AEROSPACE DATA EXCHANGE PROGRAM TRANSMITTAL

PRODUCT INFORMATION NOTICE

1. TITLE	2. DOCUMENT NUMBER
MICROCIRCUIT, MEMORY,DIGITAL,CMOS, 512 X 8-BIT, RADIATION-HARDENED SRAM MONOLITHIC SILICON	SPO-2018-PIN-0001
	3. DATE *(Year, Month, Date)* 2018, Oct, 1
4. MANUFACTURER NAME AND ADDRESS CAES 4350 CENTENNIAL BOULEVARD COLORADO SPRINGS, COLORADO 80907-3486	5. MANUFACTURER POINT OF CONTACT NAME Peter Nelson
	6. MANUFACTURER POINT OF CONTACT TELEPHONE 719-594-8238
	7. MANUFACTURER POINT OF CONTACT EMAIL Peter.b.nelson@cobhamaes.com

Summary: This ADEPT adds two guaranteed by design AC timing specifications to both the datasheet and SMD (t_{AVSK} and t_{AVET2}) which where recommendations of the previously documented application note (AN-MEM-002). Datasheet changes are also noted herein. This change replaces the data from the app note in the datasheet and adds data to the SMD to ensure that the user does not miss the timing info.

SRAM read cycle 1: address access.

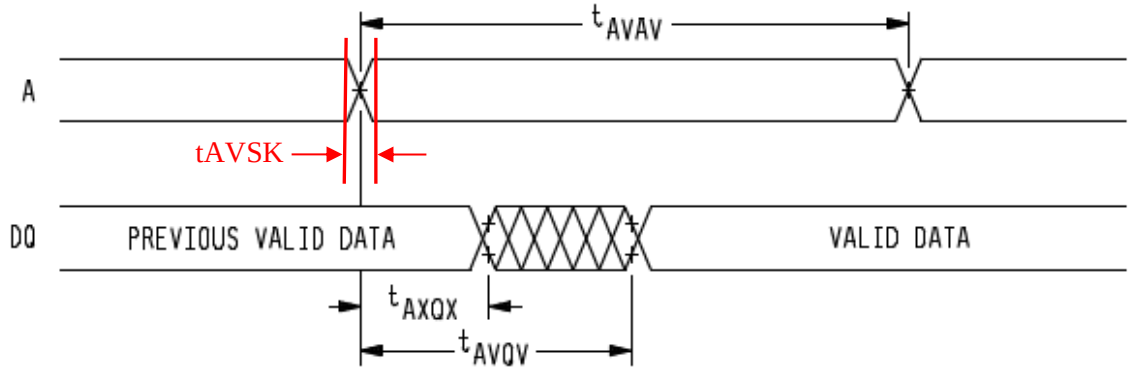
Add timing parameters to SRAM read cycle 1 and read cycle 2

Figure 4a. SRAM Read Cycle 1: Address Access

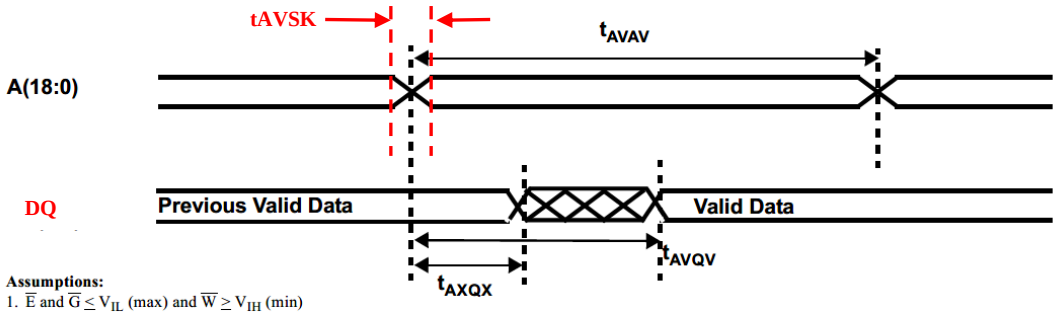
SRAM Read cycle 1 and 2
Adding parameters tAVSK and tAVET2 to timing diagrams
